SUBJECT: ELECTRIC EQUIPMENT ENVIRONMENTAL QUALIFICATION ISSUES
(NRC INSPECTION REPORT NOS. 50-348/87-30 AND 50-364/87-30)

SUBJECT: CONFIRMATION OF ACTION - DOCKET NO. 50-348

Justification for Continued Operation
J. M. Farley - Unit 1
Terminal Blocks Used In Instrument Circuits

RAYCHEM/CHICO ENVIRONMENTAL SEAL QUALIFICATION

Figure 1
Attachment 2

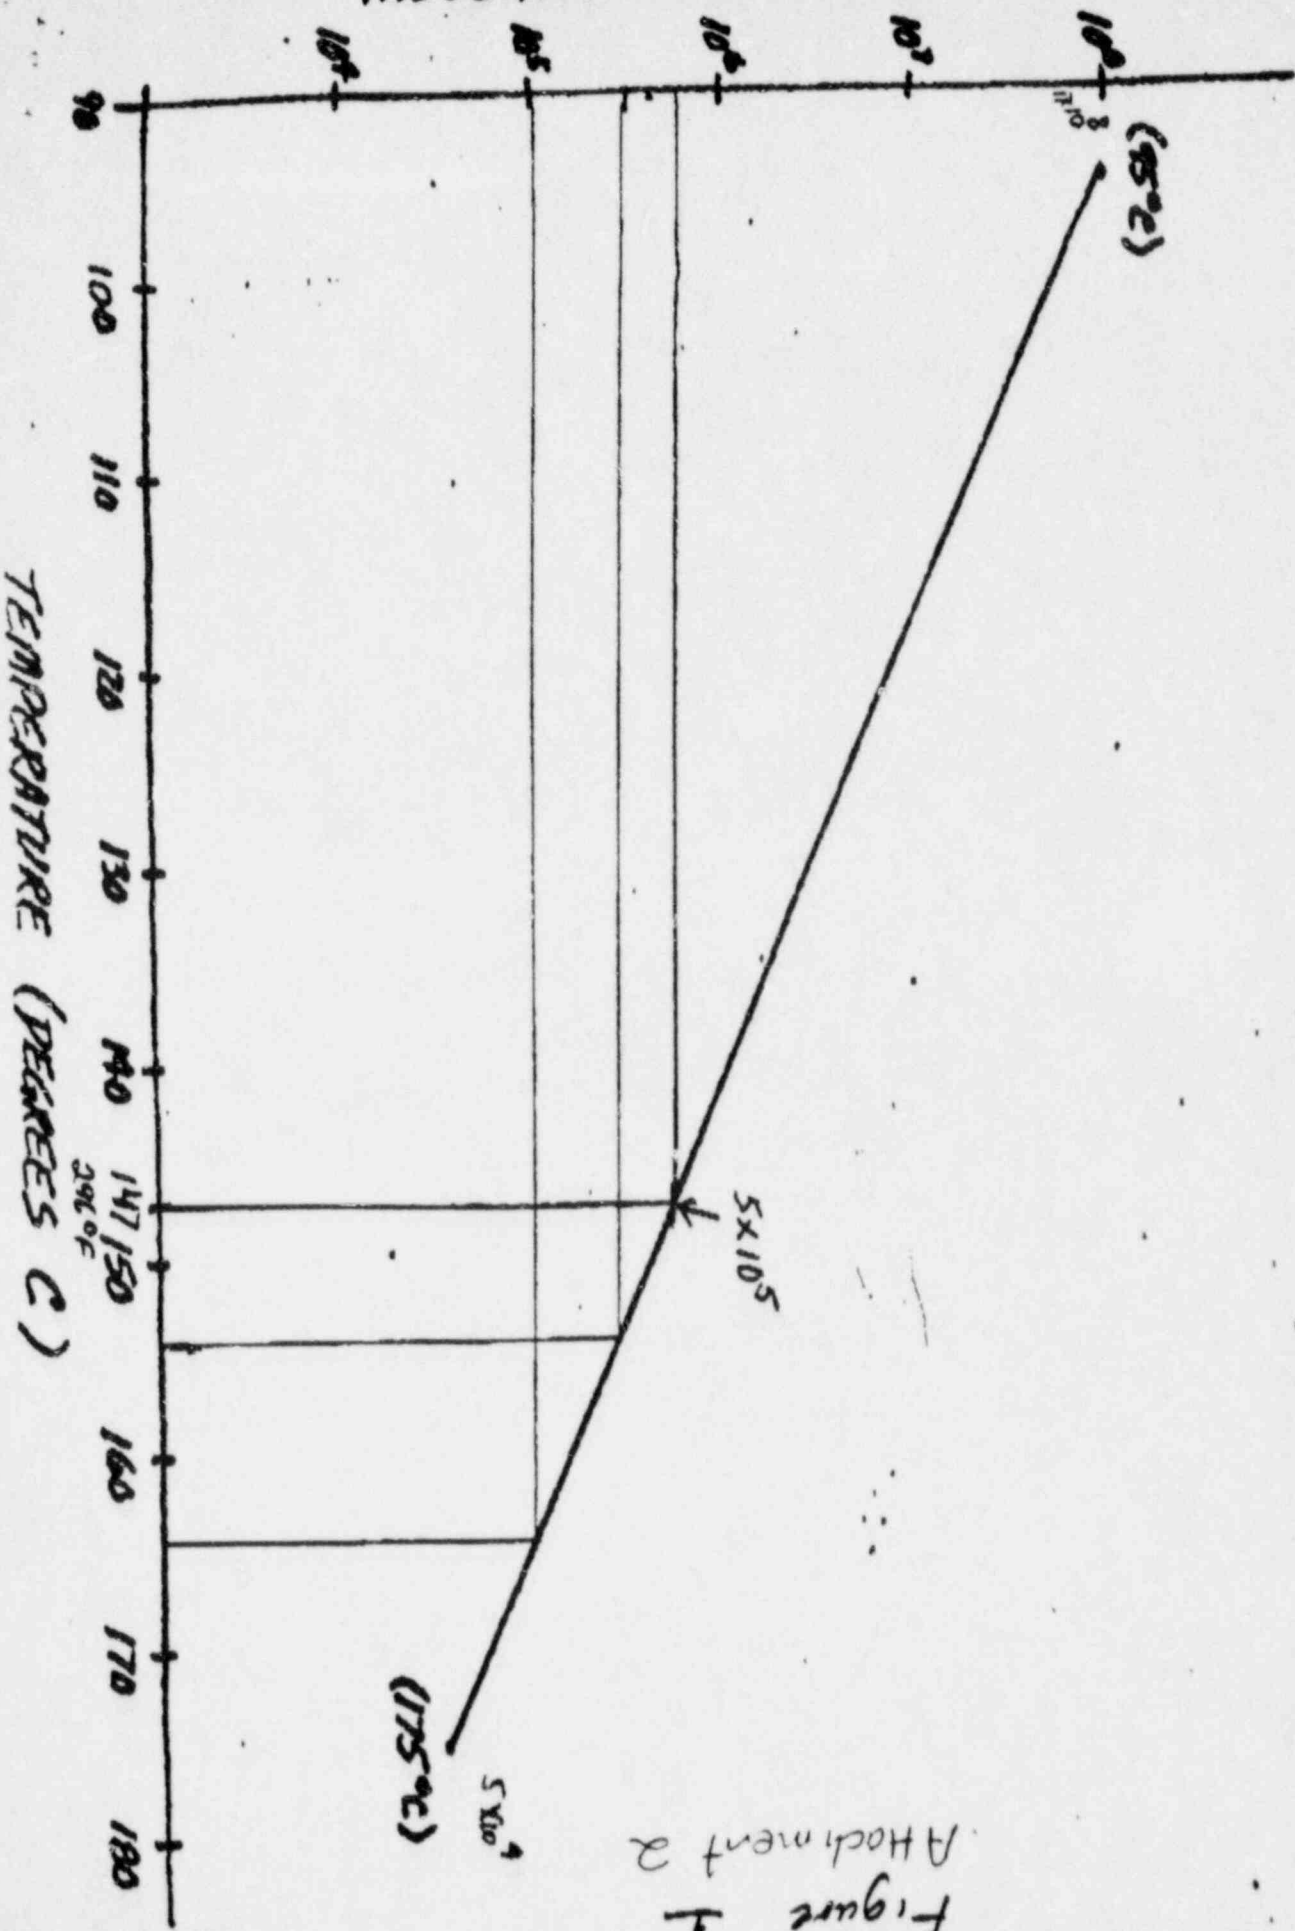
Figure 1 ← Figure 1 of Westinghouse letter dated 11/23/87 was made from plots of SAND83-1617 (SNL) Phase II test data for exposure of G.E. EB25 terminal blocks to the SNL Phase II simulated LOCA/MSLB profile (Attached Figure 2, Pg. 9 of SAND83-1617). IR test data for an EB25 block was used from the SNL report as there were no States ZWM, or CR151B blocks tested by SNL in Phase II, and the EB 25 block is similar to these FNP installed blocks. Phase I data which did record leakage currents and IR values for States ZWM and CR151B blocks was not used due to the inaccuracies associated with the SNL electrical test circuitry that measured leakage current values during Phase I testing.

Based on a review of Figure 1 and Figure 3.0-1, the instrument inaccuracy that exceeds the value that the operator can utilize with confidence occurs at a time when no operator action based on instrumentation in a harsh environment is required for the design basis events described above. For large and small LOCA, no mitigative or recovery operator actions are required based on instrumentation in a harsh environment. For secondary

FIGURE 1

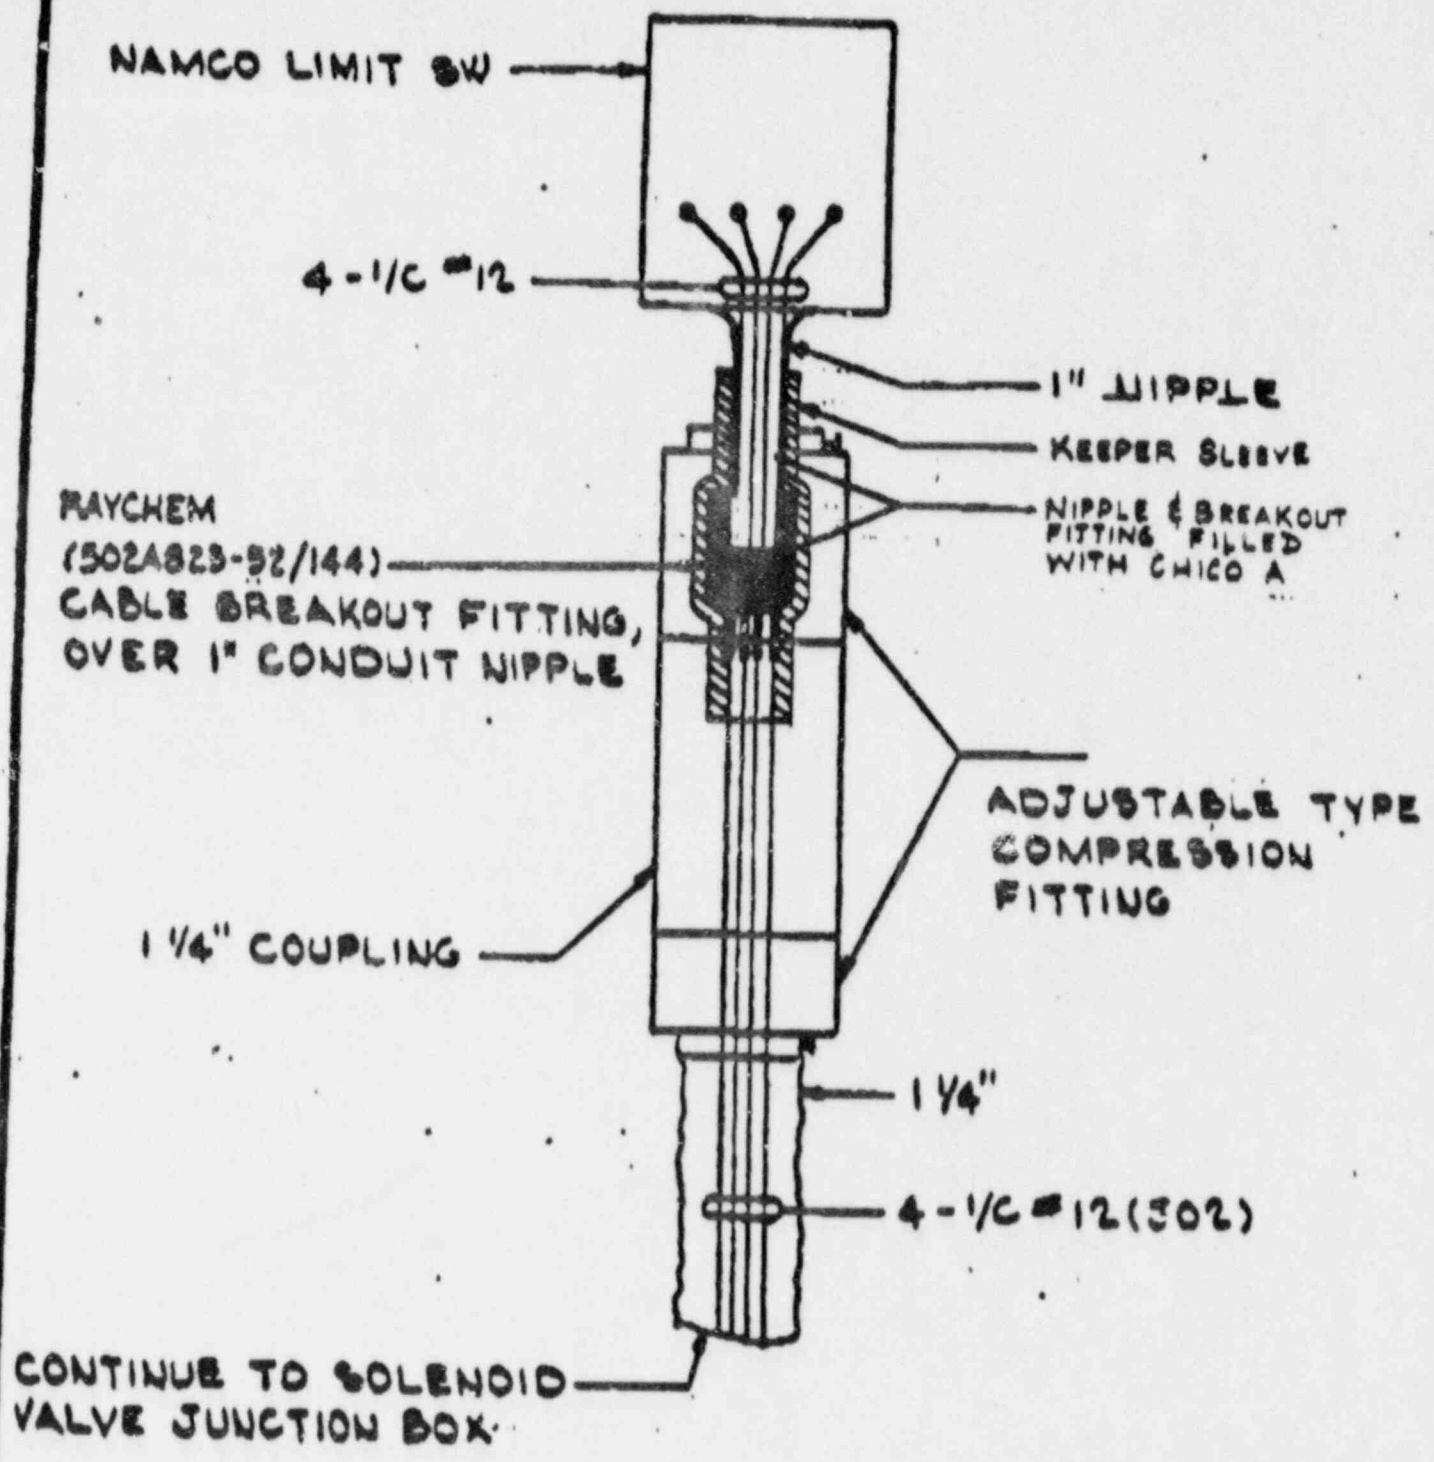
The Chico Seal qualification package has not demonstrated that Raychem will bond to conduit.

The postulated failure mechanism discussed during the audit was chemical spray during a LOCA reacting with the zinc coating on the galvanized steel nipple to form a gray powder over the nipple. The result is a path for enough moisture to enter the limit switch between the Raychem and the degraded conduit causing the limit switch to fail. The following paragraphs describe in detail the Farley configuration and its configuration relative to the postulated failure described above. In summary, it should be noted that Chico A alone provides a pressure tight seal inside the pipe nipple which provides a pressure tight seal. To provide additional assurance that moisture will not enter the limit switch, three additional barriers have been applied to the FNP configuration. They are:

- 1) Raychem breakout boot
- 2) Keeper sleeve
- 3) Compression adapter clamp

The environmental seals used with NAMCO EA-180 limit switches are composed of a Raychem WCSF breakout boot that has been shrunk onto a 1" pipe nipple attached to the limit switch (See Figure 1). The individual conductors connected to the switch pass through the breakout boot which forms a seal to the conductor insulation/jacket. To provide mechanical rigidity to the breakout boot, the nipple and the breakout boot are filled with Crouse-Hinds sealing compound (CHICO A) and allowed to cure. In addition to providing mechanical rigidity to the breakout boot crotch, the CHICO A provides an additional pressure tight barrier (seal) inside the pipe nipple which is environmentally qualified. CHICO A was qualified by test conducted by Southwest Research Institute (SWRI Project No. 03-4974-001) for use as drywell penetrations for Grand Gulf Nuclear Station. In addition, on the recommendation of Raychem, a keeper sleeve was installed over the breakout boot and the nipple to add rigidity to the boot, and to keep the boot in place during elevated accident temperatures when the adhesive softens.

In the final assembly, an appleton compression adapter is clamped over the keeper sleeve to provide support for the flexible conduit, and it also mechanically clamps the keeper sleeve to the pipe nipple.

The zinc coating on the galvanized steel nipple may interact with the chemical spray during LOCA and form a gray powder over the nipple. However, the chemical spray does not react with the Raychem S1119 adhesive (Reference Wyle Test Report No. 58442-2, Section 3.4, Page 9 and Section 3.4.2). In addition to the duration of spray at Farley is only 87 minutes and the individual conductors will be effectively shielded from the spray.

Should there be a failure of the adhesive between the pipe nipple and the breakout boot, for whatever reason, the seal assembly would remain intact because of the keeper sleeve and the clamping action of the compression adapter. If it is postulated that the breakout boot, the keeper sleeve and the compression adapter clamp all fail, the internals of the NAMCO limit switch will still be protected by the approximately 3 inch long CHICO A seal.
